SUBJECT: Savannah River Site's Responses to the Regulatory Comments on the Facility Decommissioning Evaluations for Building 484-4D, Powerhouse Maintenance Facility (G-FDE-D-00037, Revision 0, November 13, 2019), Building 484-12D, D-Area Storage Building (G-FDE-D-00038, Revision 0, November 18, 2019), Building 484-7D, D-Area Storage Building (G-FDE-D-00039, Revision 0, November 13, 2019), Building 683-D, Chlorine Unloading and Storage (G-FDE-D-00040, Revision 0, November 13, 2019), Building 454-D, D-Area Diesel Fuel Tank (G-FDE-D-00041, Revision 0, November 13, 2019), Building 484-13D, D-Area Storage Building (G-FDE-D-00042, Revision 0, November 18, 2019), and Building 484-15D, D-Area Storage Building (G-FDE-D-00043, Revision 0, November 18, 2019) Simple Model

**SRS Responses to U.S. Environmental Protection Agency
Comments on the Facility Decommissioning Evaluations for the
Facility Decommissioning Evaluations for Building 484-4D, Powerhouse Maintenance Facility
(G-FDE-D-00037, Revision 0, November 13, 2019), Building 484-12D, D-Area Storage Building
(G-FDE-D-00038, Revision 0, November 18, 2019), Building 484-7D, D-Area Storage Building
(G-FDE-D-00039, Revision 0, November 13, 2

454-D Sump Interior (March 2020)

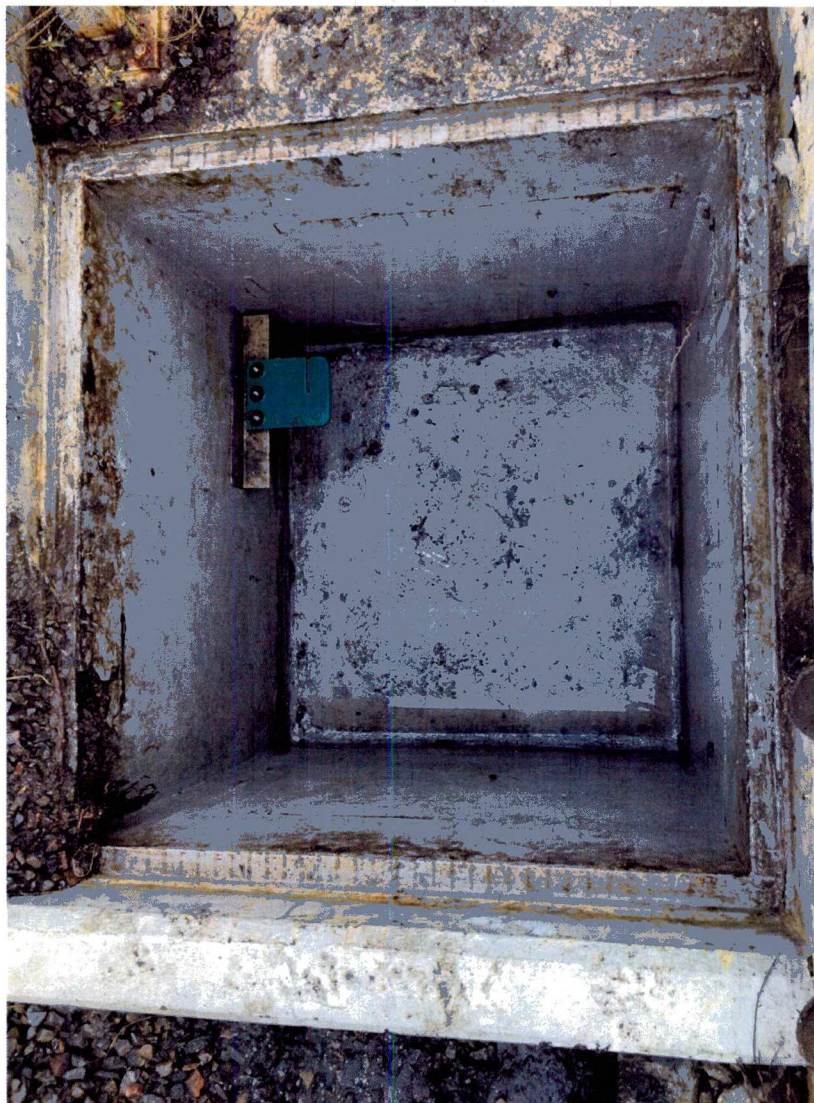
- 2) EPA requests Building 454-D, D-Area Diesel Fuel Tank Loading Facility which includes 2 Sumps use the Integrated Sampling Model for facility decommissioning, as outlined below:
 - a. EPA requests that if staining is noted within the 2 sumps after the emplaced rock/gravel is removed:
 - i. Samples will be taken within each sump along with a photographic log throughout the sump decommissioning activities
 - b. If no staining is noted, please document with photo logs in the Building 454-D Area Diesel Fuel Tank Loading Facility DPF

Response: Clarification. The integrity of the sump was not compromised during the operation of the facility based on the review of operating records, spill reports, interviews with the operating organization and a March 2020 inspection of the current state of the sump. (see photos below). The facility was a fuel storage area and managed during its operation in accordance with all regulatory requirements and standards up until its shutdown. During the 2012 to 2014 timeframe, deactivation of facilities was taking place throughout the D-Area complex. In 2014, as part of the deactivation of 454-D and 454-1D, residual surface stains within the dike area of 454-D and the concrete pad/dike area of 454-1D were pressure washed. The sumps of both facilities were inspected, pressure washed, and filled with rock. A walkdown of the facilities was performed on February 27, 2020, at which time the rock-filled sumps in 454-D and 454-1D were not visually accessible, and their condition and subsurface release potential could not be assessed. DOE believes that if the sumps had been visually accessible during the walkdown, their integrity, condition, and potential for release would not have created uncertainty. The rocks were removed from the sumps in March 2020 and the sumps have been re-inspected and

photographed (see below for photos). DOE believes the sumps' condition warrants Simple Model decommissioning for 454-D. No change to the FDE is proposed

Figure 2. Interior and Exterior Views of 484-4D Storage Buildings

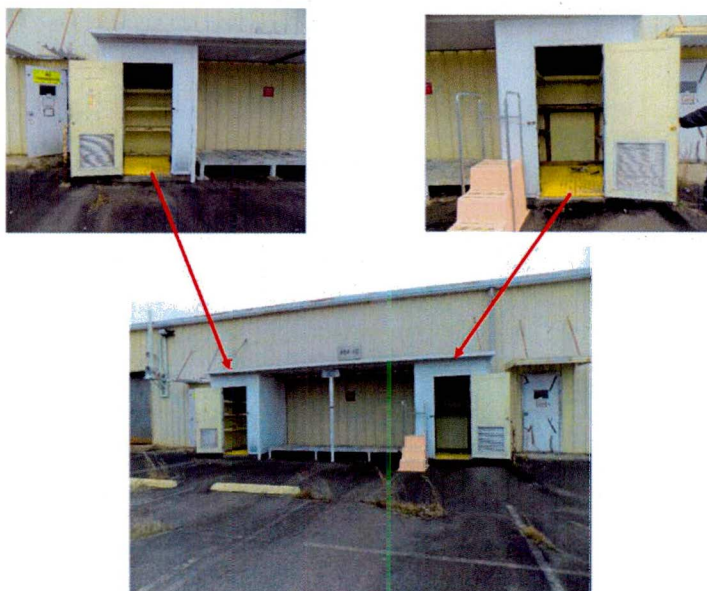
- d. Please include exterior and interior pictures of the 2 small storage buildings and the covered area between them

Response. Agree. Figure 2 provides interior and exterior views of the two small storage buildings and the covered area. No change to the FDE is proposed.

Figure 1. D-Area Aerial Overview

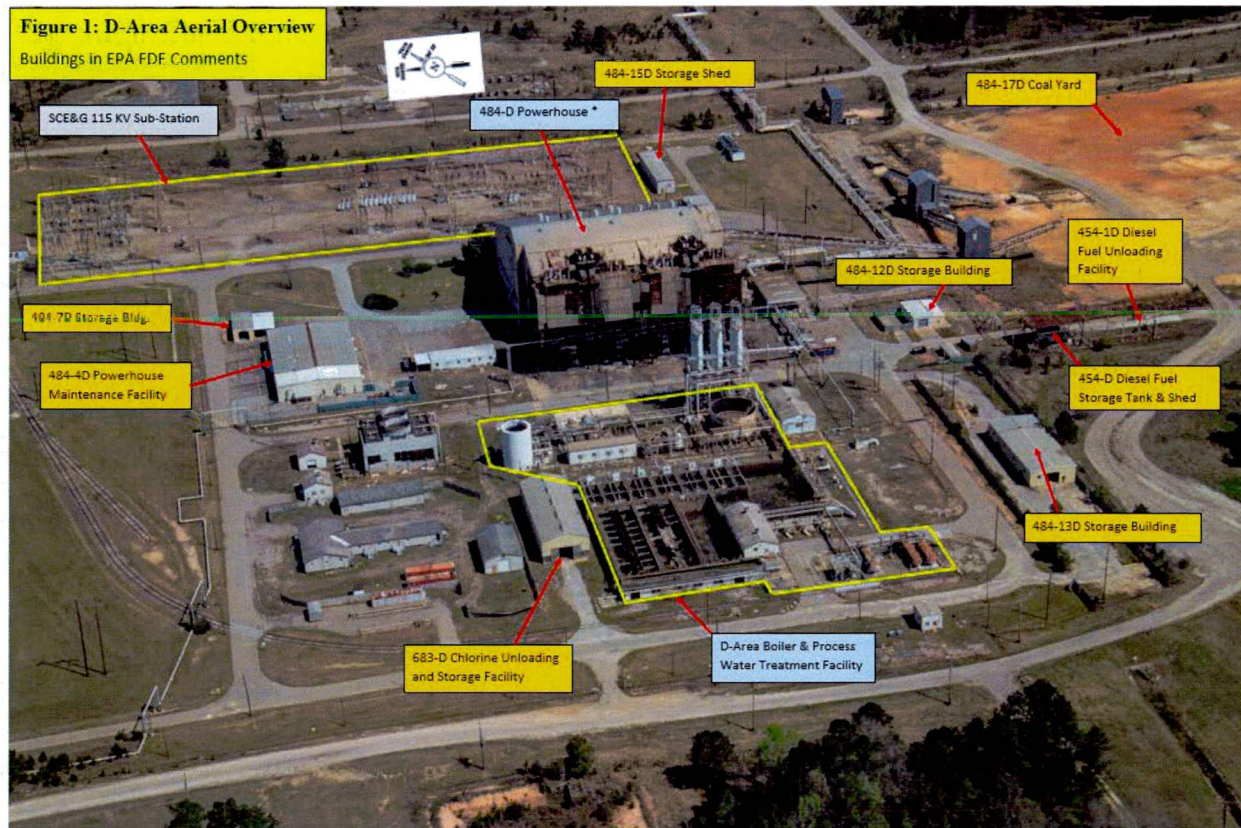
- 3) Please provide one figure that depicts the relationship between the 7 buildings and their ancillary structures

Response. Agree. Figure 1, D-Area Aerial Overview, (on page 21 of 38) shows the FDE buildings and their relationship to the 484-D Powerhouse, the D-Area Boiler and Process Water Treatment Facility, and the 115 KV SCE&G Sub-Station. No change to FDE is proposed.

454-D Sump Interior (March 2020)

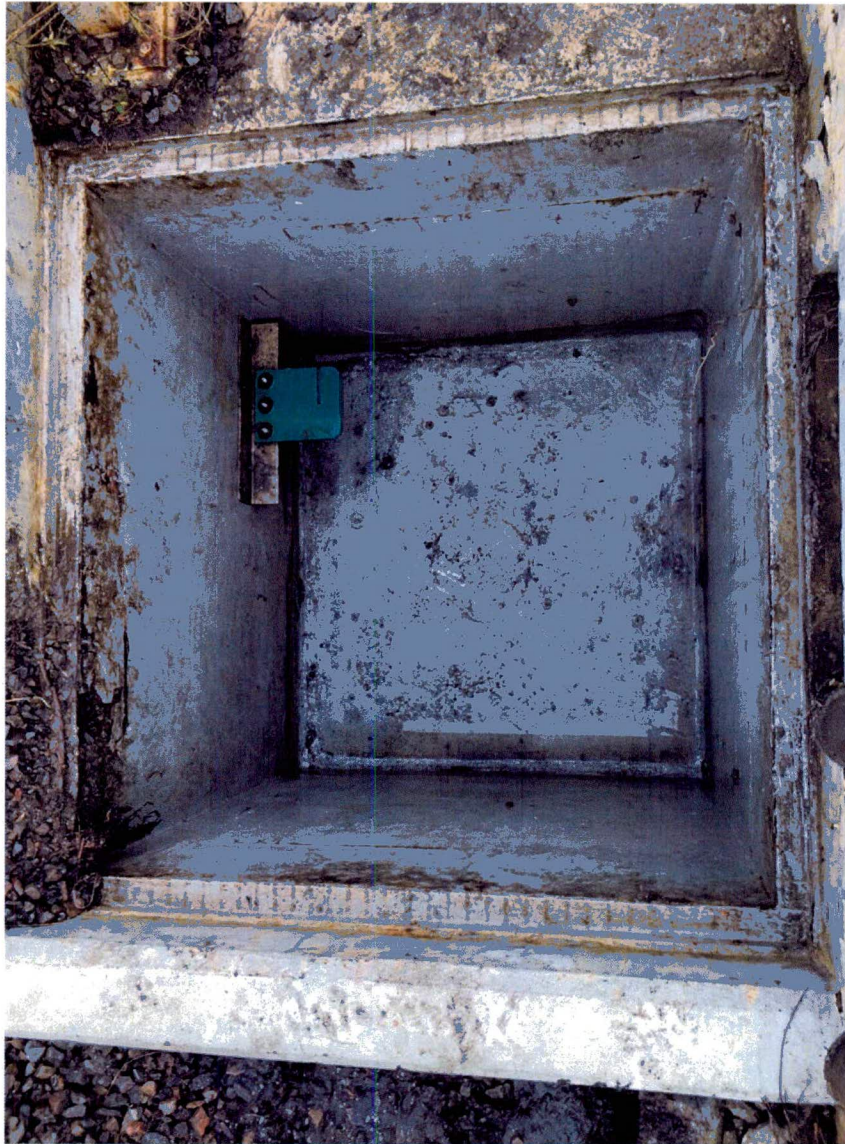
The integrity of the sumps for Diesel Fuel Tank and the Diesel Fuel Unloading Facility are not specifically addressed. Please address.

Response: Clarification. The integrity of the sump was not compromised during the operation of the facility based on the review of operating records, spill reports, interviews with the operating organization and a March 2020 inspection of the current state of the sump. (see photos below). The facility was a fuel storage area and managed during its operation in accordance with all regulatory requirements and standards up until its shutdown. During the 2012 to 2014 timeframe, deactivation of facilities was taking place throughout the D-Area complex. In 2014, as part of the deactivation of 454-D and 454-1D, residual surface stains within the dike area of 454-D and the concrete pad/dike area of 454-1D were pressure washed. The sumps of both facilities were inspected, pressure washed, and filled with rock. A walkdown of the facilities was performed on February 27, 2020, at which time the rock-filled sumps in 454-D and 454-1D were not visually accessible, and their condition and subsurface release potential could not be assessed. DOE believes that if the sumps had been visually accessible during the walkdown, their integrity, condition, and potential for release would not have created uncertainty. The rocks were removed from the sumps in March 2020 and the sumps have been re-inspected and photographed (see below for photos). DOE believes the sumps' condition warrants Simple Model decommissioning for 454-D. No change to the FDE is proposed
